REVIEW OF ADEQUACY OF ENVIRONMENTAL MITIGATION IN THE ESIA FOR THE EAST AFRICA CRUDE OIL PIPELINE IN UGANDA

ENVIRONMENTAL AND SOCIAL IMPACT ASSESMENT

AUGUST 2019

Figure 5. Photographs of the open-cut buried pipe section that ruptured and the replacement pipeline bridge¹⁸

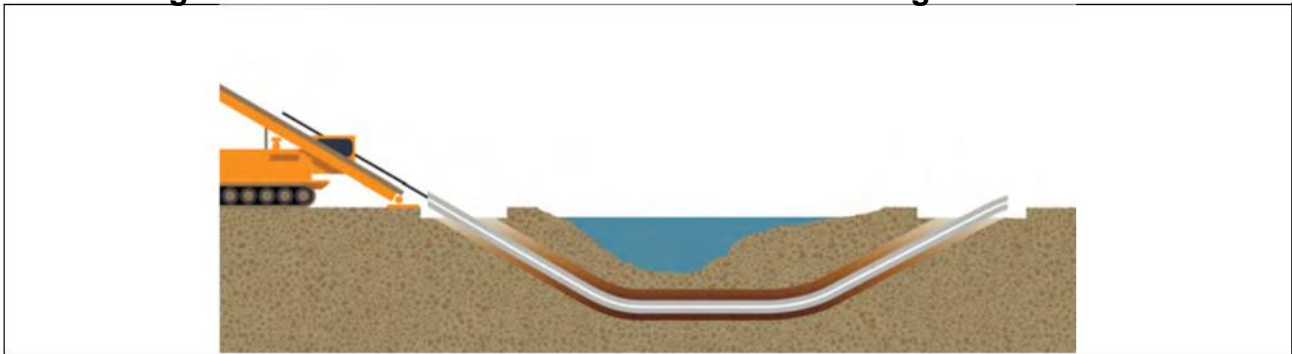
Open-cut trenching of pipelines in streambeds carries operational risks. A major rupture on the Camisea liquids pipeline in Peru occurred sixteen months after the pipeline began operation at a point where the pipeline had been placed under the streambed of the Paratori River using open-cut trenching.¹³ The river is less than 10 meters across where the rupture took place. The pipeline was exposed due to scouring of the streambed during a period of heavy rain.¹⁴ It had been buried 2.1 meters below the stream bed.¹⁵

The automatic leak detection system did not register that a leak had occurred. The pressure reduction caused by the rupture “was not sufficiently large to activate the automatic rupture detection mechanism of the block valves upstream and downstream of the rupture.”¹⁶ The rupture was detected when control room operations staff identified a reduction in flow at the downstream pump station. The nearest block valves were ultimately closed about one hour after the rupture occurred. Approximately 4,600 barrels of liquid hydrocarbons were spilled into the stream.¹⁷ Figure 5 shows the damaged pipe section and the pipeline bridge that replaced the pipeline section that had been buried under the streambed.

Figure 6.4-1 Protected Areas in the Area of Influence

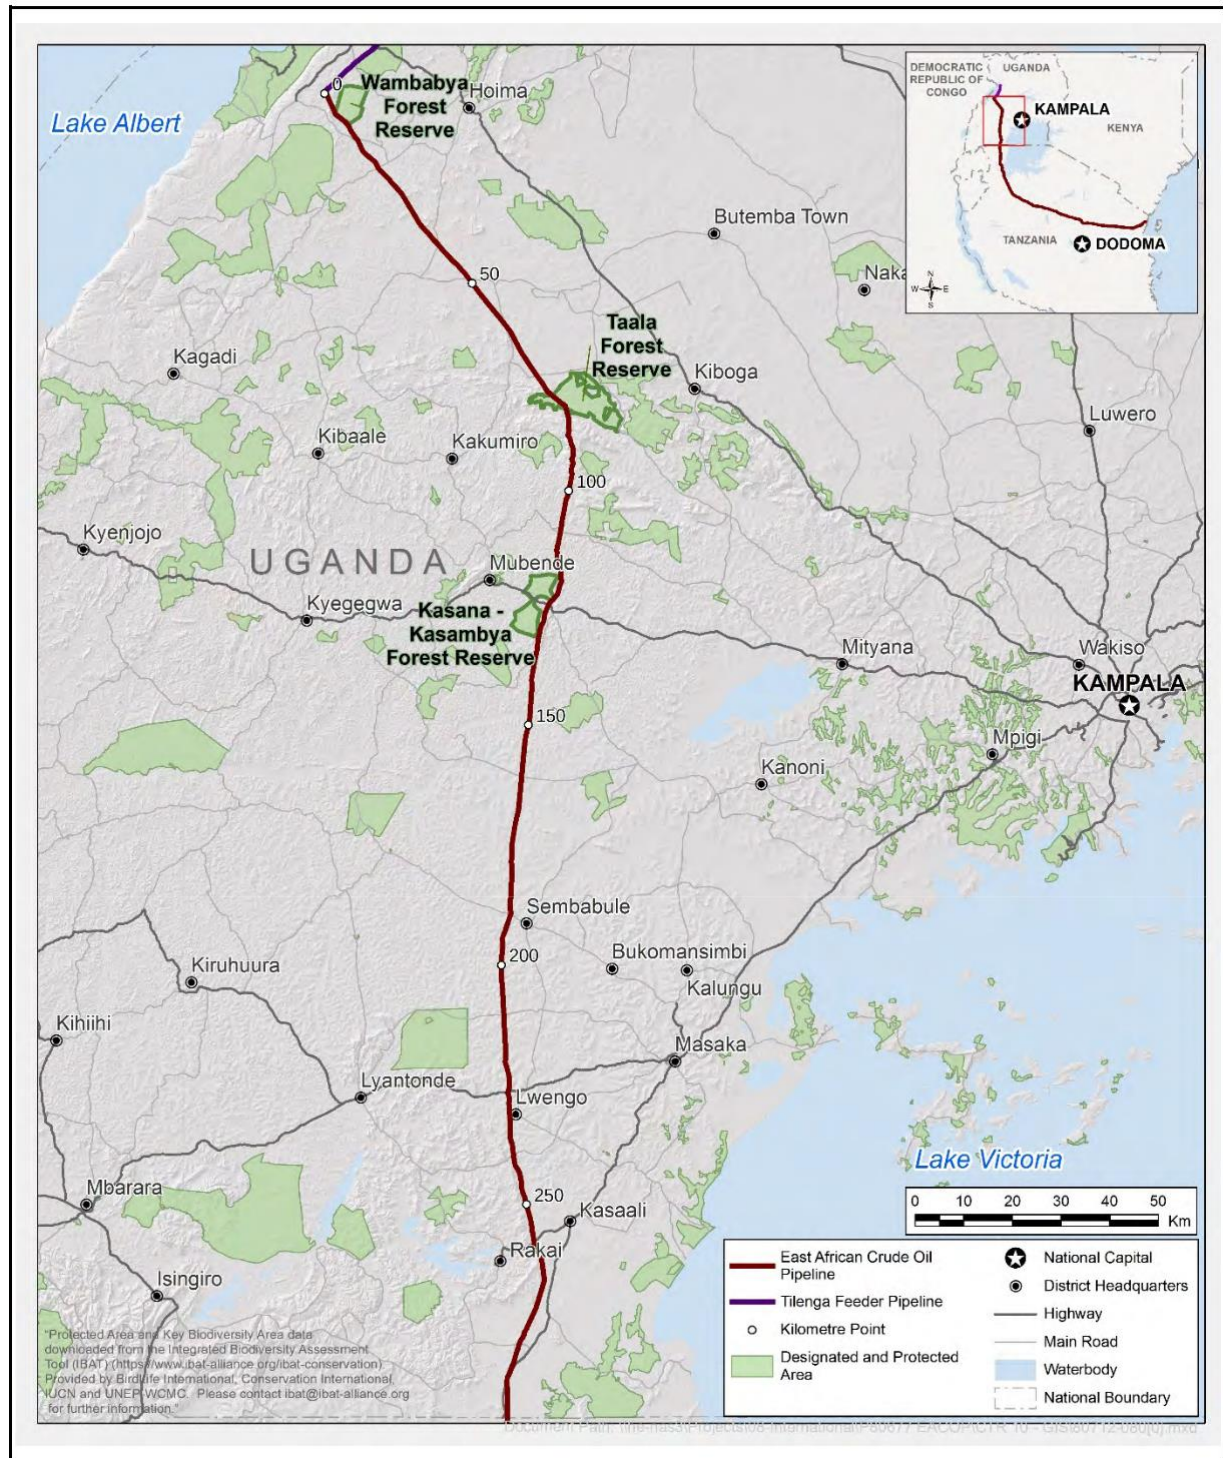
The proposed EACOP route will pass through or near Figure 3. 8-meter construction ROW¹⁰ three protected forest areas: between Wambabya and Bugoma Forest Reserves, the Taala Forest Reserve in Kyankwanzi District, and near the eastern border of Kasana-Kasambya Forest Reserve. The ESIA map showing the locations of these protected forest areas relative to the EACOP route is provided in Attachment B.

The maximum width of the construction ROW in protected forests should be no more than 10 meters. The primary reasons for this width restriction is to: 1) minimize the amount of ground-level disturbance in the protected area, and 2) maintain canopy bridges at regular intervals along the ROW to allow for the passage of forest animals that live primarily or exclusively in the tree canopy. Figure 3 is a photograph of a construction ROW cross-section limited to 8 meters in the Peruvian jungle. Canopy bridges were maintained at regular intervals along this ROW.

Figure 6.4-7 Main Watercourse Crossings and Catchments

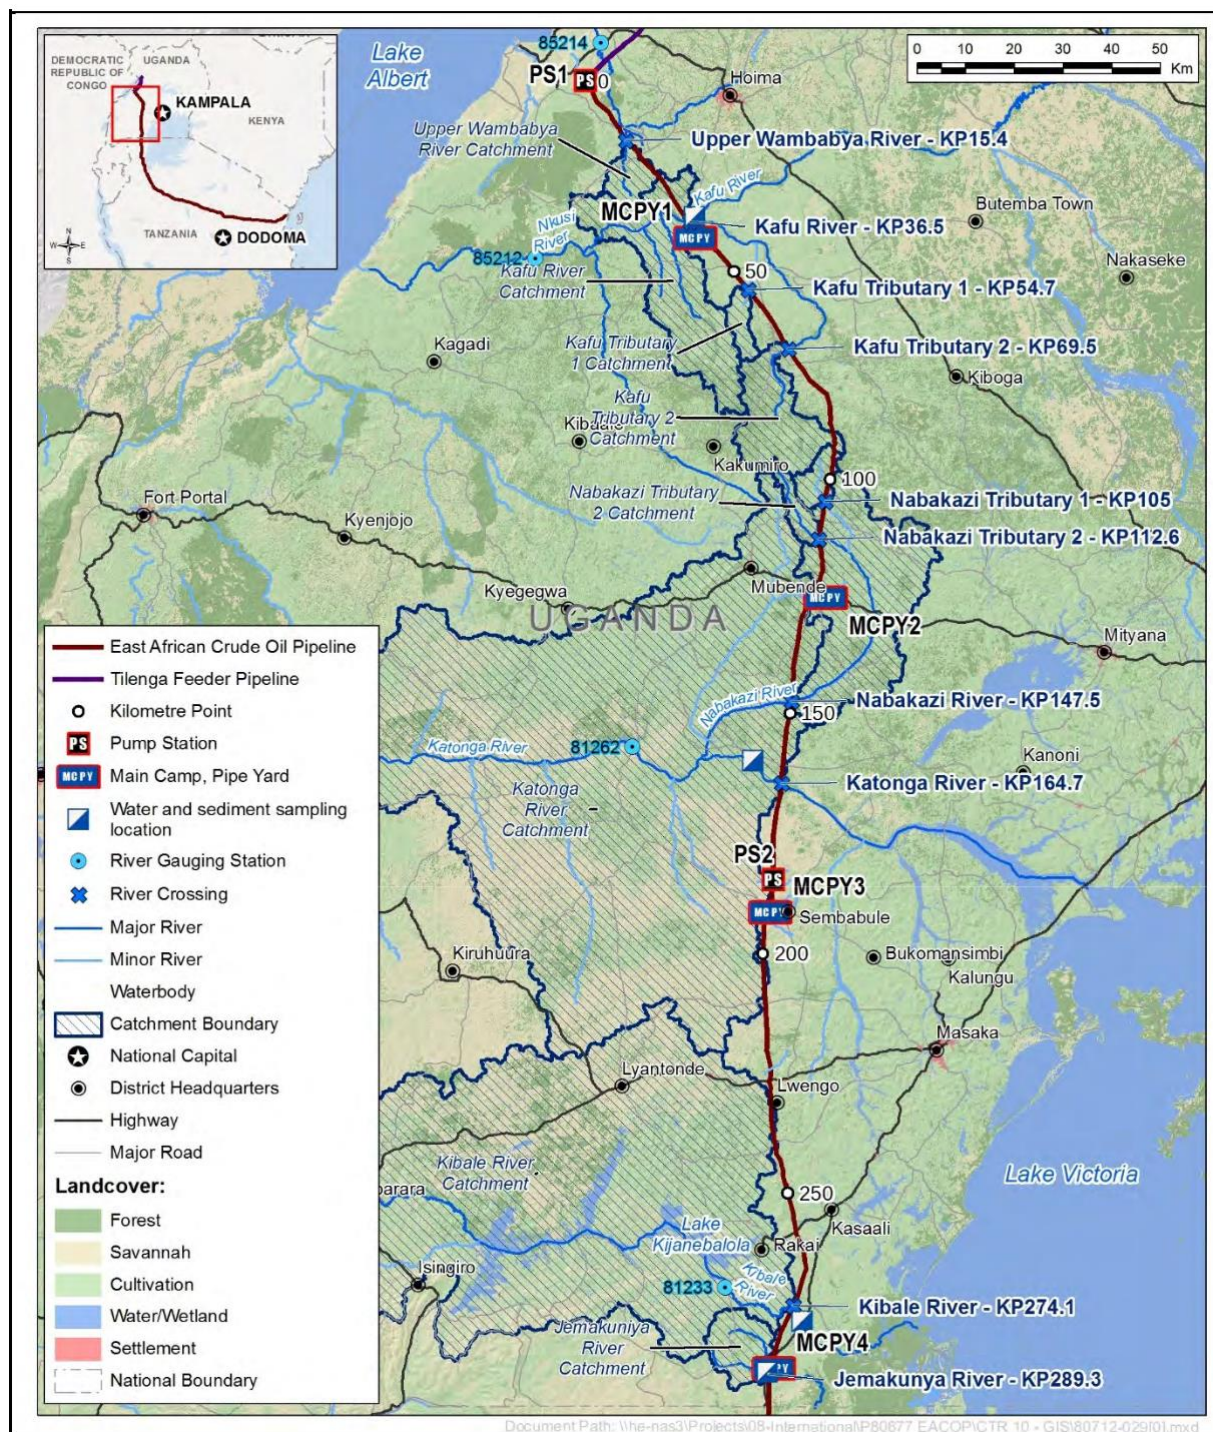
In summary, HDD is best practices for traversing the ten major waterbody crossings along the pipeline route in Uganda. As noted, the total width of these ten waterbody floodplains is approximately 2 km. HDD has no construction footprint on the waterbody itself. HDD has no construction footprint on the waterbody itself. In contrast, open-cut has a large and negative footprint, at least temporarily, on the waterbody. Therefore about 2 km of HDD will be necessary to traverse these ten waterbody floodplains.

Best practice is to install block valves on either side of perennial rivers and streams, not just on either side of rivers greater than 30 m wide. A spill into a perennial river or stream less than 30 m in width will have major environmental consequences regardless of what is downstream of the point of the spill. Block valves should be installed on both sides of the ten major waterbody crossings identified in the ESIA (Table 6.4-18), in addition to the block valves already included in the project design.
